## 35-TYPE CONVERTER SETS — ADJUSTMENTS

*APPARATUS AFFECTED:* 35A, 35B, 35D, 35E, 35F, 35G and 35H Converter Sets.

- (1) To simplify adjustment methods and requirements.
- (2) To revise and update wiring diagrams.

**1.19 GEAR MECHANISM****(A) INTERMEDIATE SHAFT  
REQUIREMENT**

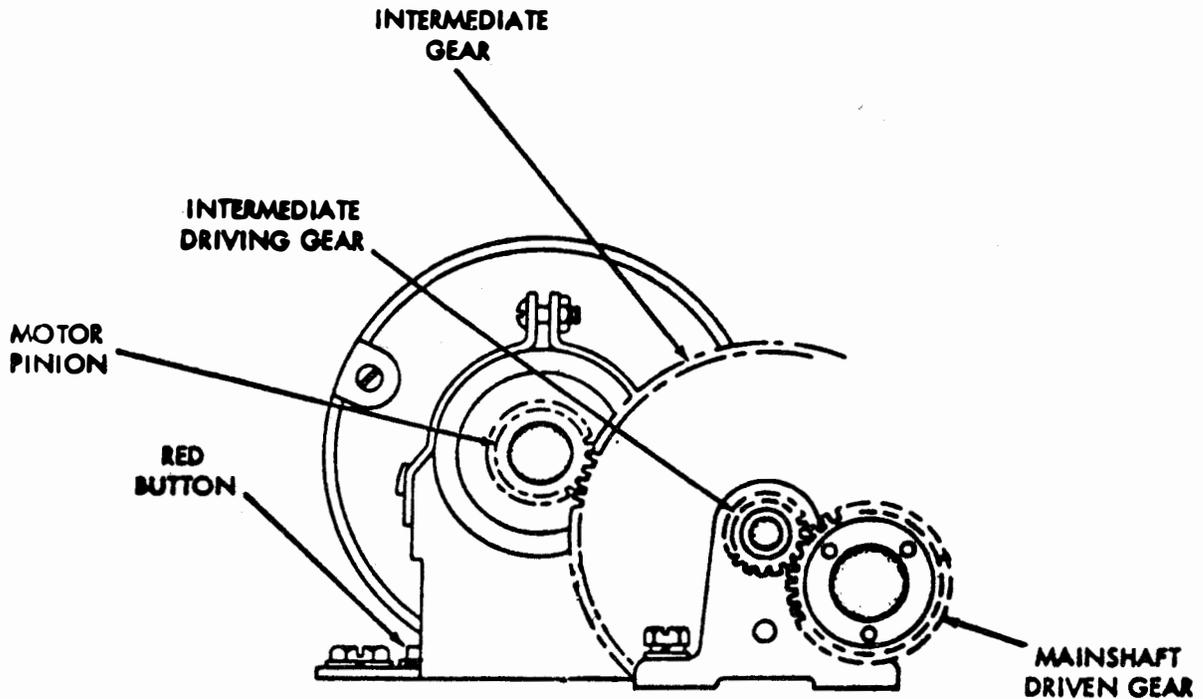
(1A) *Section 570-106-700, Issue 3, Page 30, Paragraph 3.19*

The location of subparagraph (A) on page 30 has been changed and will read as subparagraph (B) Tape Reader Gear Backlash.

The requirement (A) Tape Reader Gear Backlash has been changed:

From: "Only a perceptible amount of backlash between main shaft driven gear and intermediate driving gear."

To: "Only a perceptible amount of backlash between main shaft driven gear and intermediate driving gear at point where backlash is least."

The location of subparagraph (B) on page 30 has been changed and will read as subparagraph (A) Intermediate Shaft.

The requirement of Min. 0.015 inch—Max. 0.020 inch has been deleted.

"To Adjust" of new (A) Intermediate Shaft, has been changed:

From: To Adjust.

Position the intermediate shaft assembly to the forward plate loosened.

To: To Adjust.

Loosen the two intermediate gear bracket screws and position intermediate gear bracket.

The note to subparagraph (B) Intermediate Shaft, has been changed:

From: Note: Intermediate shaft adjustment required only on miniaturized base.

To: Note: In some cases, it may be necessary to loosen the motor mounting screws and position the motor to meet the requirements.

ONLY A PERCEPTIBLE AMOUNT OF BACKLASH BETWEEN THE MOTOR PINION AND INTERMEDIATE GEAR AT POINT WHERE BACKLASH IS LEAST.

LOOSEN THE TWO INTERMEDIATE GEAR BRACKET SCREWS AND POSITION INTERMEDIATE GEAR BRACKET.

**NOTE:** IN SOME CASES IT MAY BE NECESSARY TO LOOSEN THE MOTOR MOUNTING SCREWS AND POSITION THE MOTOR TO MEET THE REQUIREMENT.

ONLY A PERCEPTIBLE AMOUNT OF BACKLASH BETWEEN MAINSHAFT DRIVEN GEAR AND INTERMEDIATE DRIVING GEAR AT POINT WHERE BACKLASH IS LEAST.

LOOSEN THREE TAPE READER MOUNTING SCREWS AND POSITION TAPE READER.
